[EXTERNAL] RE: RC245697 Site Visit

Please find attached and below a partial (less the Flood Cert) s.92 response.

227 Hunters Road, Dunsandel, Canterbury – Proposed Chicken Sheds – Response to S92 Queries

Lifestyle Chickens

Figure 3: Map of Sensitive Receptors

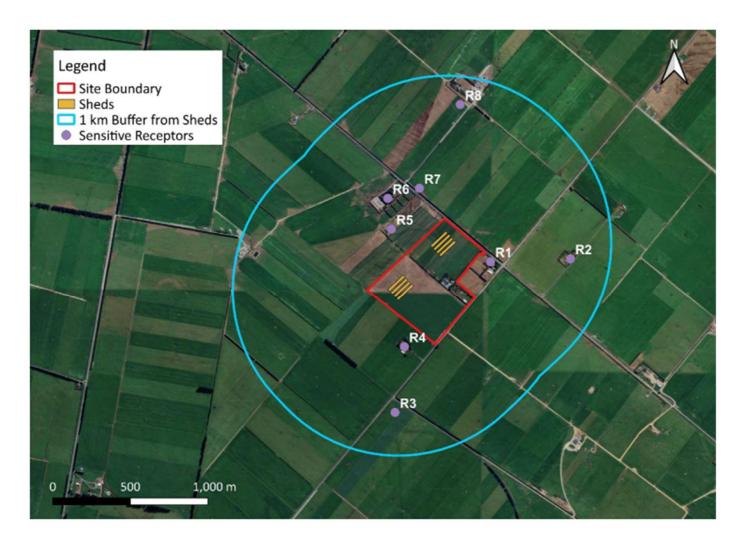
Additional s.92 queries:

- 17. Please amend the site plans to show the distances between the proposed Intensive Primary Production and the notional boundaries of sensitive land uses, including the dwellings at the application site, 319 and 375 Sharlands Road. This distance identification has already been completed within Section 5.1 of the PDP Air Quality Assessment. However, for ease of reference I have provided this information in the attached PDF (Notional Boundary Plan). I have also confirmed that these measurements are taken from the notional boundary of the identified sensitive receptors.

Earthworks Plan			
design	scale	job no.	
Danielle S	1:2000		
drawn	revision	drawing no.	
Danielle S	Rev 1		
date	checked	A00	
24 June 24		AUU

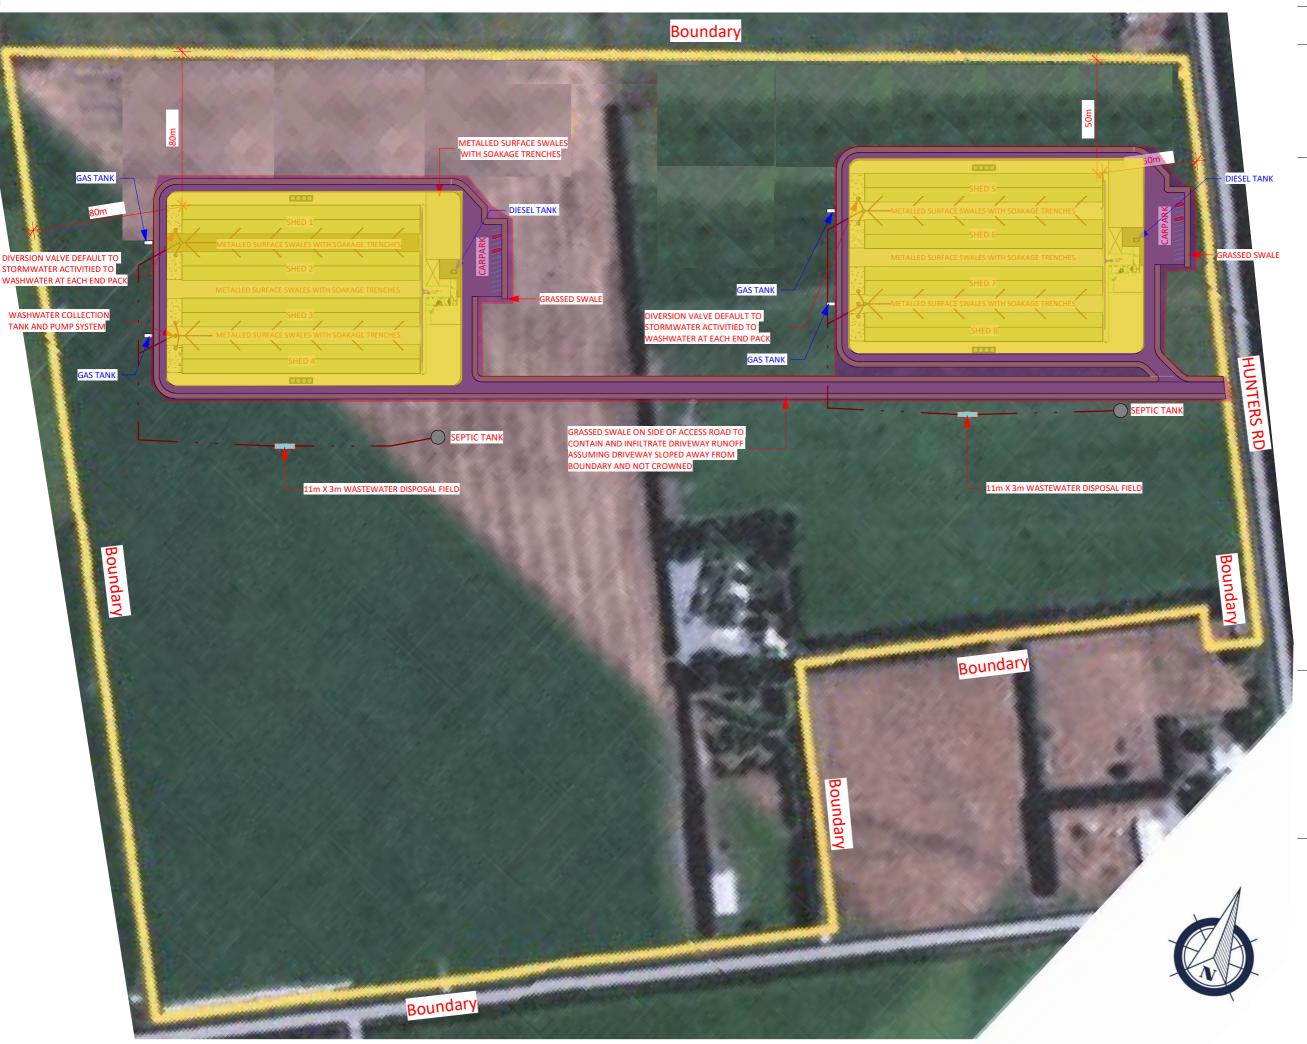
- 18. Please provide a site plan showing the depth, volumes and locations of the proposed earthworks, Attached (Concept Earthworks Plan)
- 19. Please provide details of artificial lighting to demonstrate compliance and/or non-compliance with the Partially Operative Plan's lighting standards. No external artificial lighting has been selected and it is impractical to specify a model of external light and determine its particular light spill until such time as construction for this project has been approved by both Councils and the applicant, construction doesn't have to start for up to 5 years before the consent lapses. That said, any lights mounted on the sheds will be directed at the ground around the sheds and will be screened by the proposed landscaping. We would expect a condition requiring that the Light Spill, Glare and Sky Glow PA standards within the POSDP be met.

Approx. earthworks area = 5ha (50,000m²)

- Building specific earthworks area (in yellow) = 32,000m2
- Car Parking, driveways etc earthworks area (in purple) = 18,000m2

Expected topsoil stripping depth = 200mm

Earthwork Volumes:

Building Specific = 6,400m3

Car Parking, driveways = 3,600m3

Total volume = Approx. 10,000m³
